Title of Document:	Request for Change	Issue No. G21-04665	Rev. 0
Customer:		Issue date: July 9, 2021	
Title subject:	SUH connector: Resin material change	Revision date:

SUH connector

Part number: SUHR-***V-S-*

Photo: Appearance of SUH connector (socket)

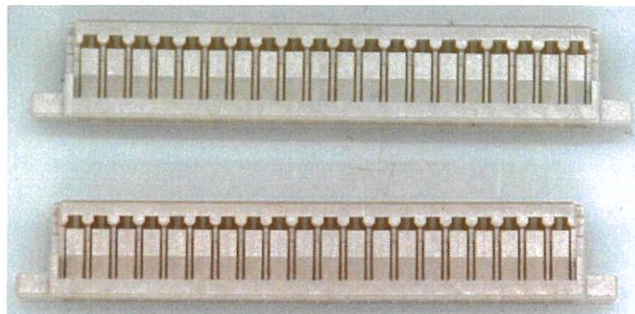
The housing resin material manufacturer for the aforementioned product shall be changed as follows. According to this change, the product performance remains unchanged.

However, due to this change, the color tone of the appearance will slightly change as shown in the photo.

Before change	After change
DIC LD-235	TORAY L304X35Z
